City of South Bend

BOARD OF ZONING APPEALS

AGENDA

Monday, January 6, 2025 - 4:00 p.m.

Proposed Site Plan

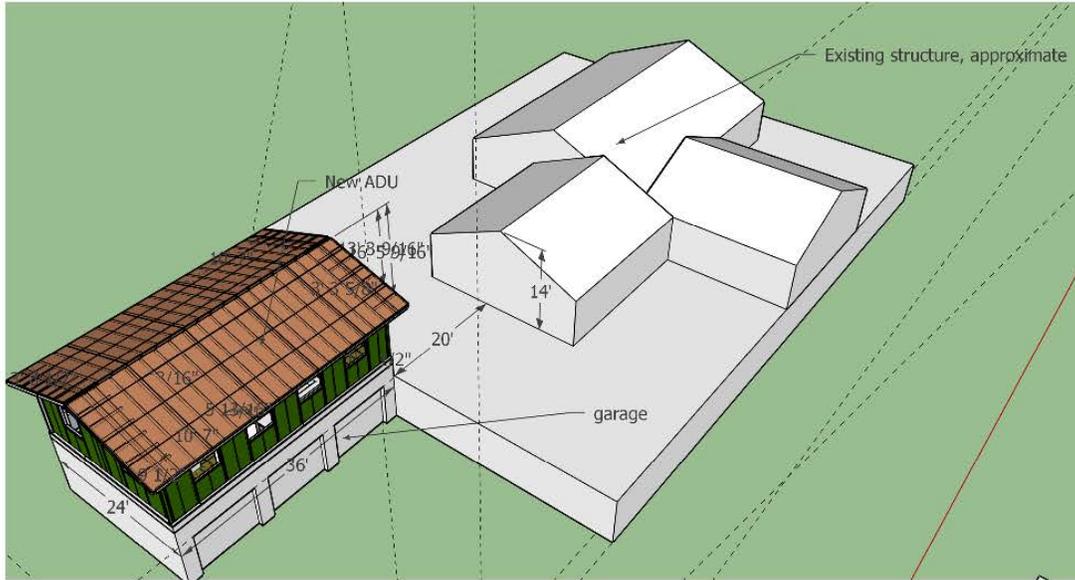
Analysis: The ADU will be set over 170' from the front property line and, with a steep grade behind the primary structure, will be 2' 6" taller than the house, making it imperceptible from the street. The proposed ADU will be clearly incidental and subordinate to the primary structure, meeting the intent of the ordinance.

Staff Recommendation: Based on the information provided prior to the public hearing, the staff recommends the Board approve the variance as presented.

FRONT of House DRAWING
FOR DOOR

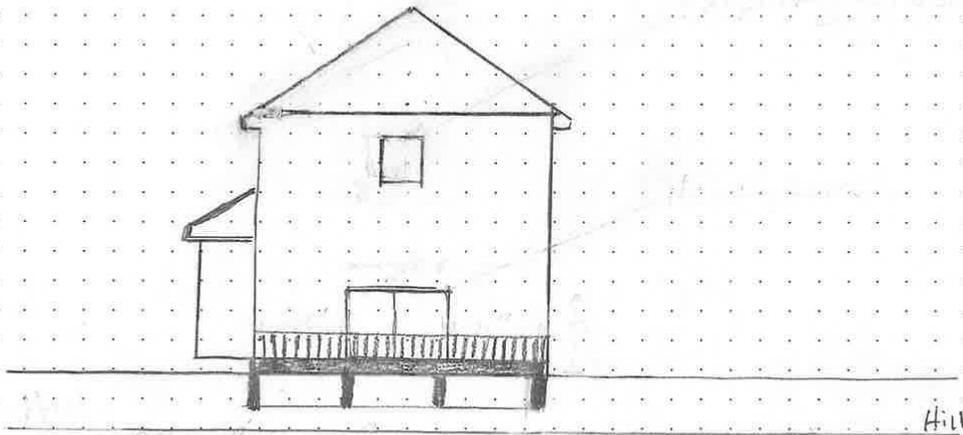
Analysis: There are no practical difficulties or unique characteristics that would warrant a deck being built within the front setback, possibly City right-of-way. The petitioner increased the size of the front deck without first obtaining a building permit. There is nothing preventing the deck from being constructed in conformance with the zoning ordinance. Staff could be favorable if it were designed as a frontage type with the deck no closer than 18" from the front property line with a connection to the City sidewalk.

Staff Recommendation: Based on the information provided prior to the public hearing, the staff recommends the Board deny the variance as requested.

Proposed Site Plan

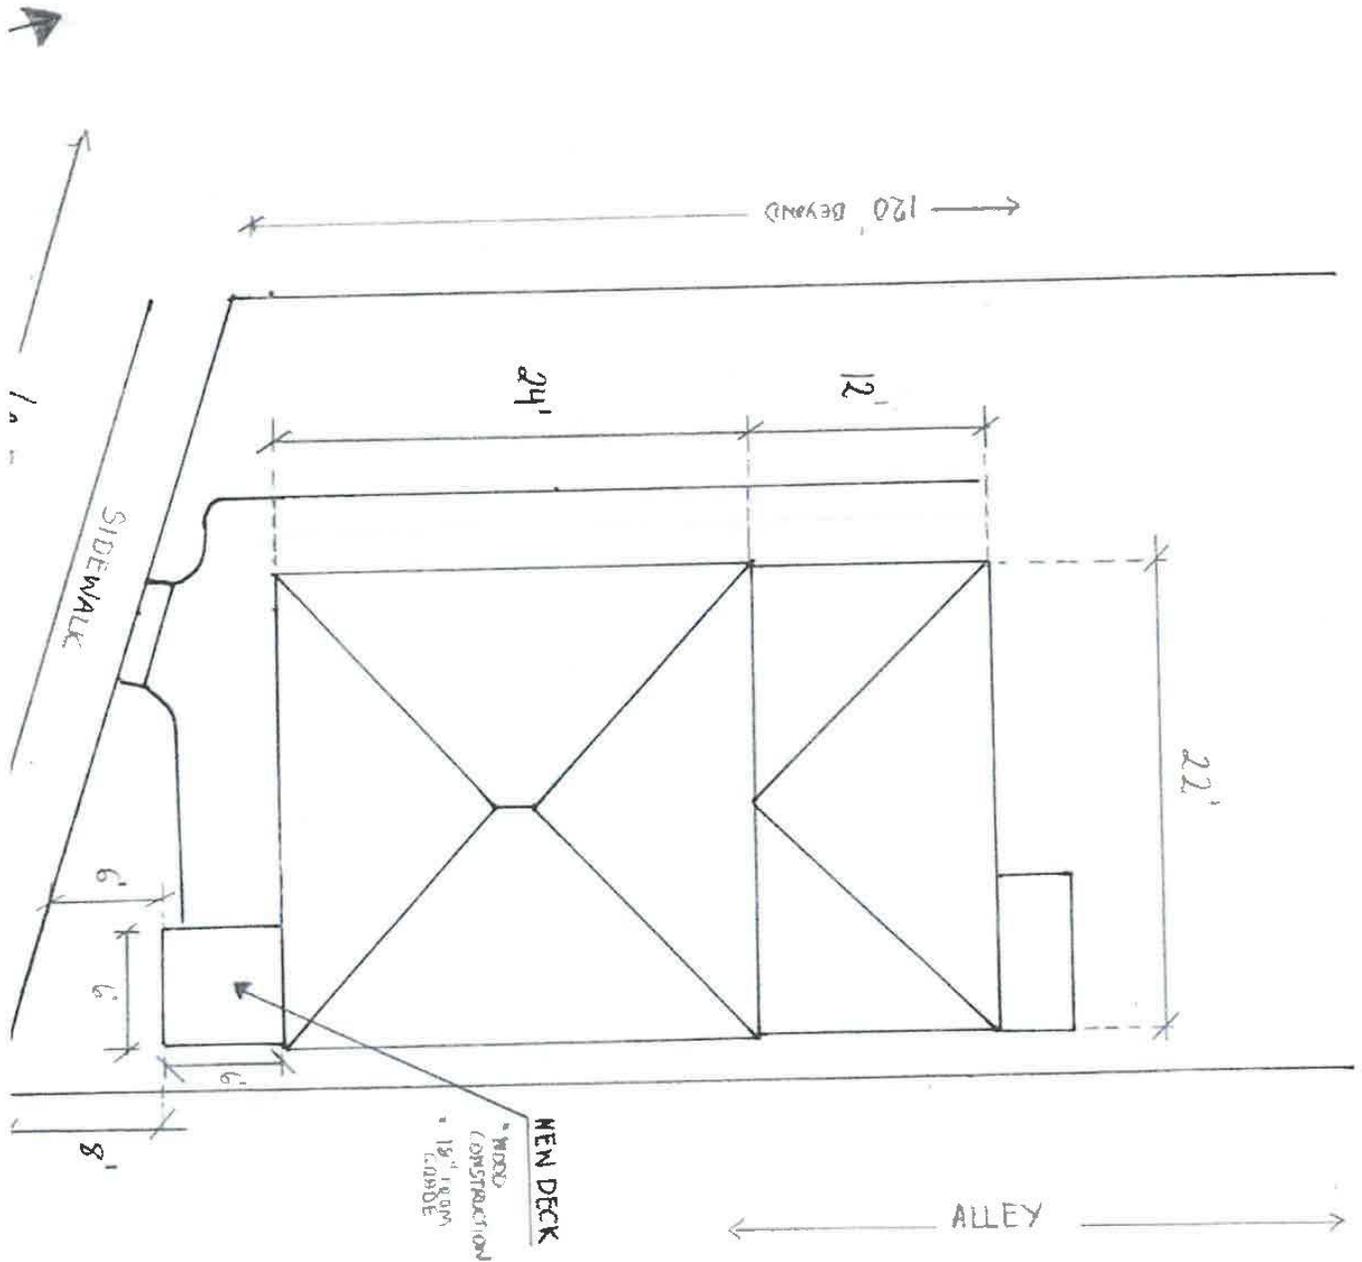
Analysis: Building a zoning compliant frontage type would encroach into the minimum front setback due to the siting of the house on the lot. The owner is looking to replace a damaged porch with a stoop that has a smaller footprint.

Staff Recommendation: Based on the information provided prior to the public hearing, the staff recommends the Board approve the variance as presented.

THE EXCHANGE 12/12/24 2

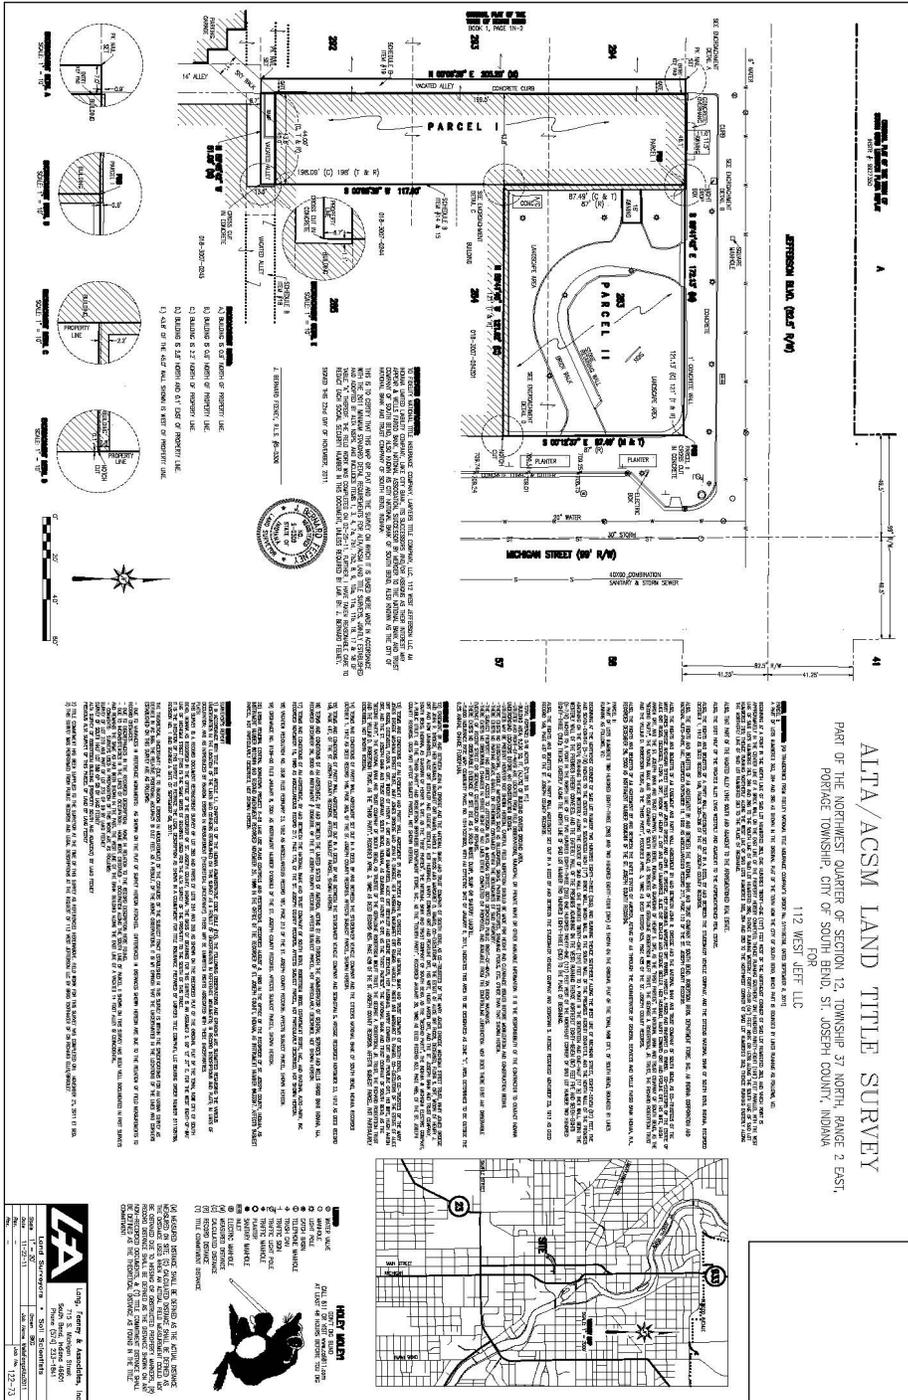
Analysis: Allowing Whiskey Exchange to project a sign above the second story will allow the business, which is focused on "nightlife", the opportunity to be more visible when many adjacent businesses are closed for the evening. The sign also meets all other standards, i.e. size, not flashing nor changing colors.

Staff Recommendation: Based on the information provided prior to the public hearing, the staff recommends the Board approve the variance as presented.

Proposed Site Plan

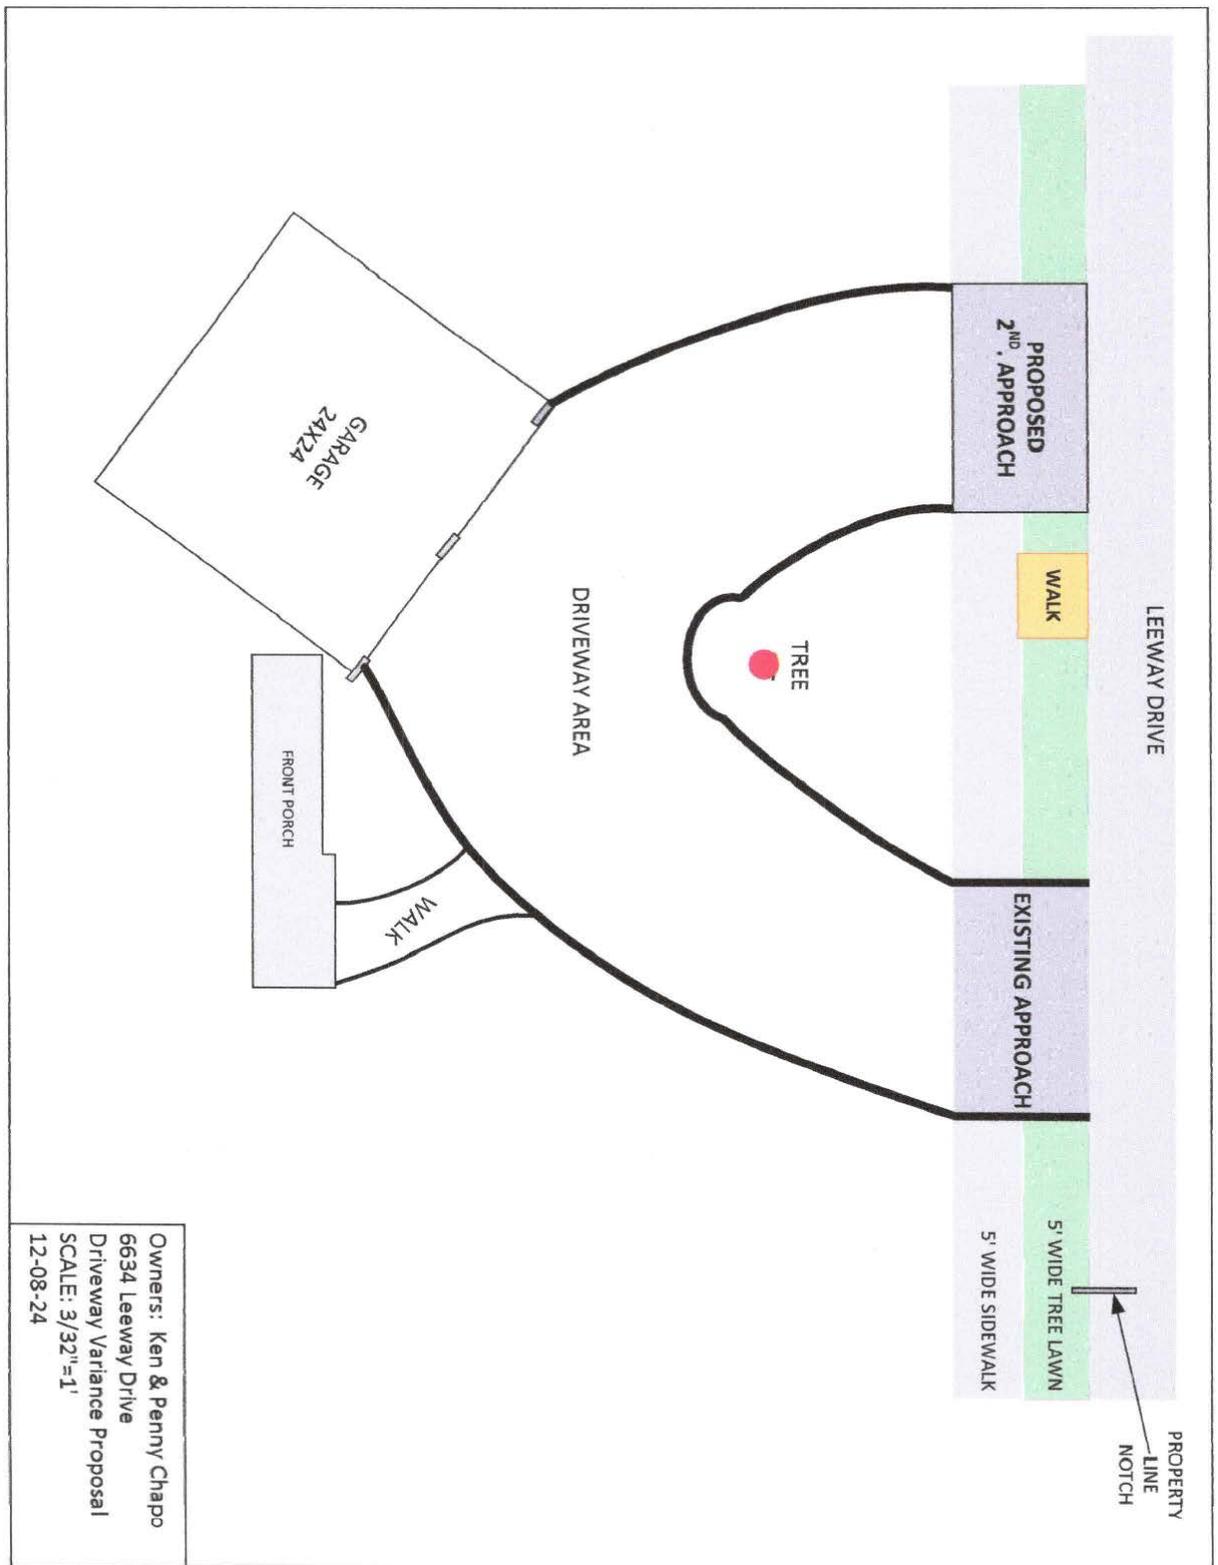
Analysis: There are no practical difficulties or unique characteristics that support the requested variance. There is nothing preventing the driveway from being constructed in conformance with the zoning ordinance and approved driveway permit.

Staff Recommendation: Based on the information provided prior to the public hearing, the staff recommends the Board deny the variance as requested.

UNIVERSITY OF NOTRE DAME
 GREAT LAKES CAPITAL SOUTH END
 SITE DIMENSIONAL PLAN

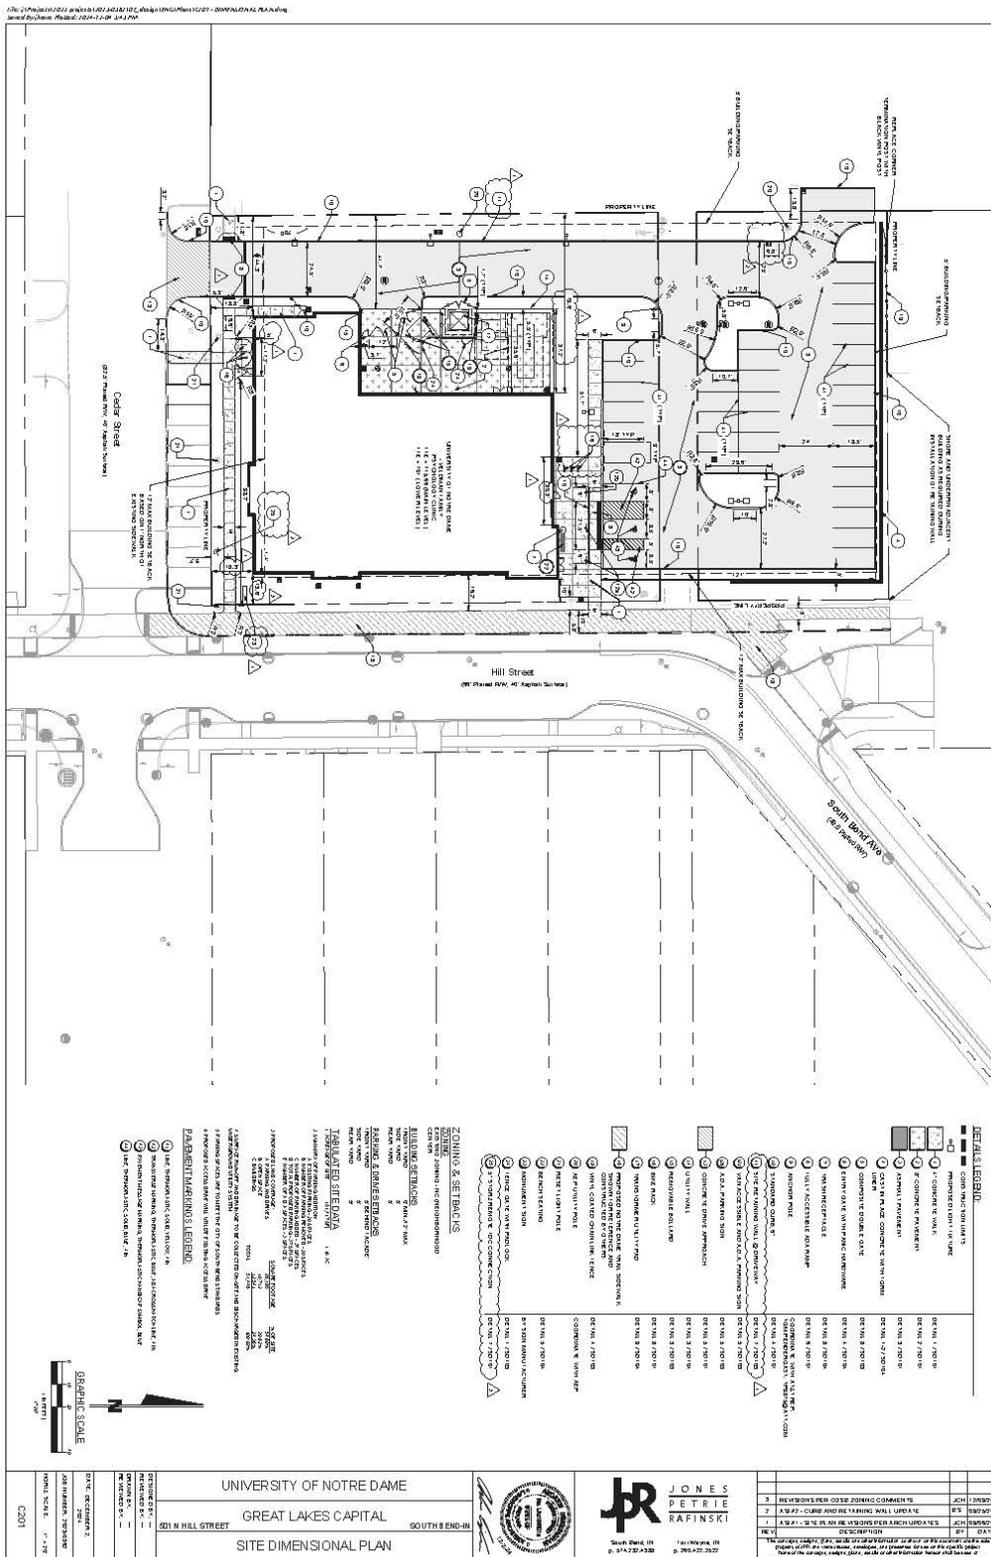
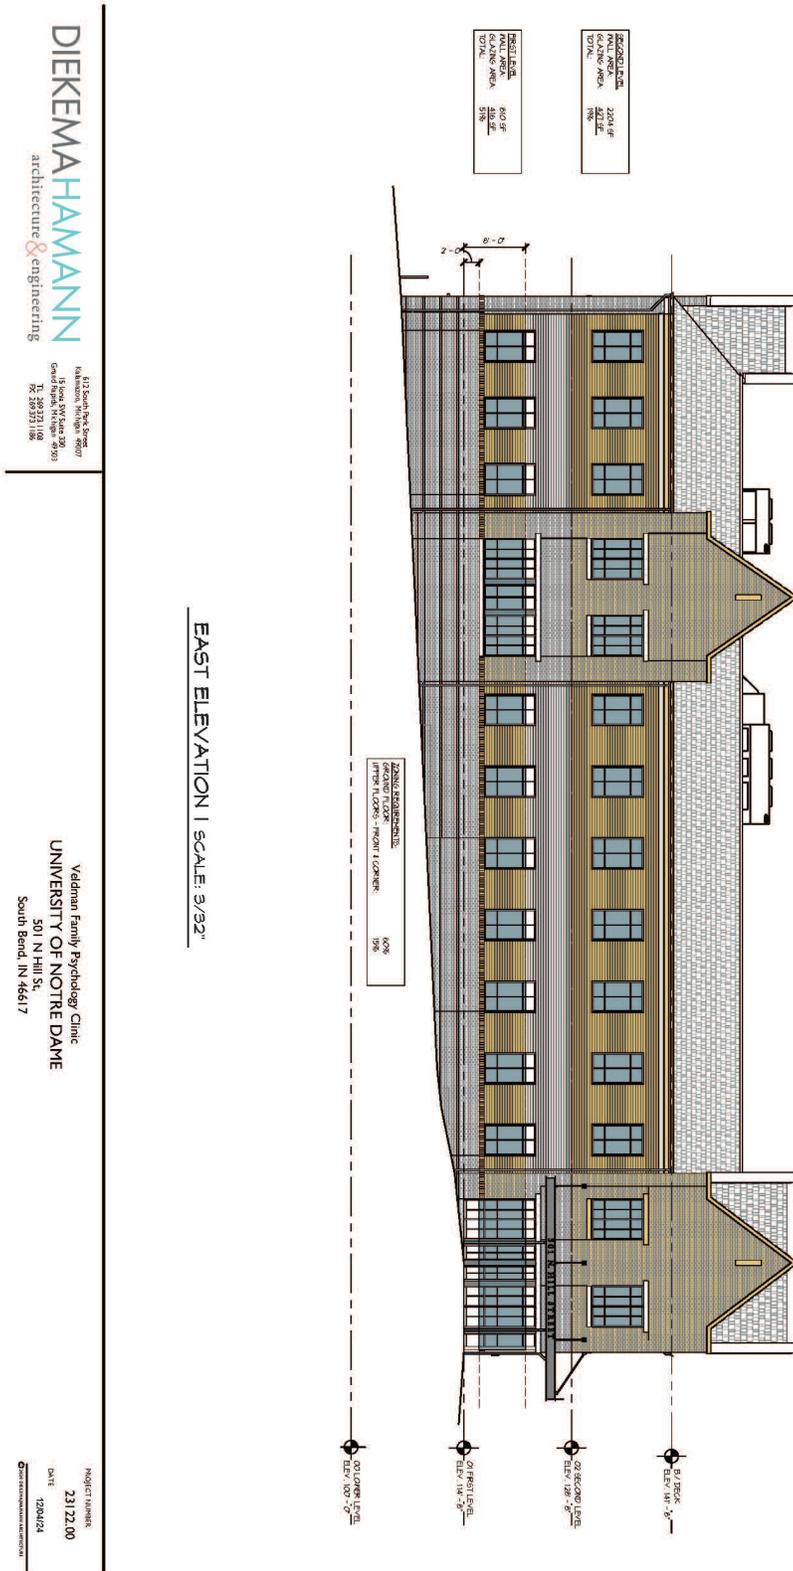
Analysis: With a steep grade from north to south, the entrance at the north facade is one floor above the entrance at the south facade. As a result, the majority of the east facade at the exterior ground level is in between floors inside the building, creating a practical difficulty in providing an entrance facing east. As a medical facility, the building provides a welcoming storefront entrance while the remainder of the first floor offers transparency that is appropriate for the use and context of the building.

Staff Recommendation: Based on the information provided prior to the public hearing, the staff recommends the Board approve the variances as presented.

Proposed Site Plan

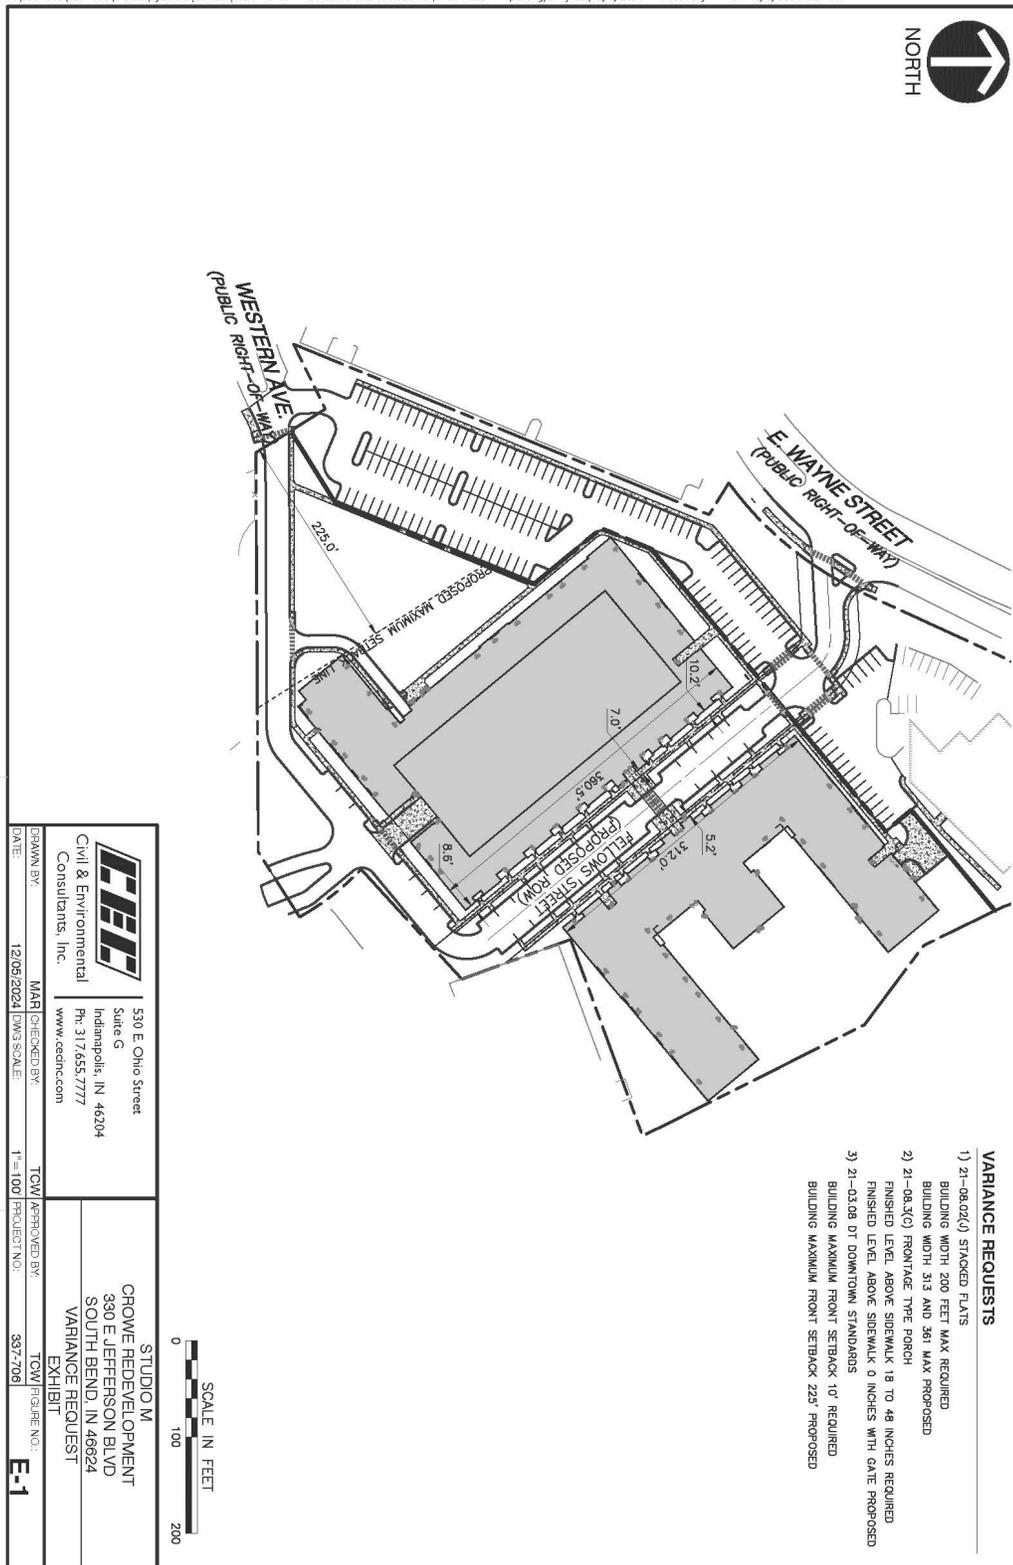
Analysis: This project fits into a broader River West Concept Plan, creating buildings that help to define a new street network along the river front. The massing of the buildings will be broken up through changes in color, materials, the use of bump outs, and a sky walk. The stoops effectively differentiate between public and private space through the use of railings and landscaping and provide well defined entries into individual units. The setback variance responds to the existing configuration of the lot. The buildings will meet DT Downtown standards when the new street is dedicated to the City.

Staff Recommendation: Based on the information provided prior to the public hearing, the staff recommends the Board approve the variances as presented.
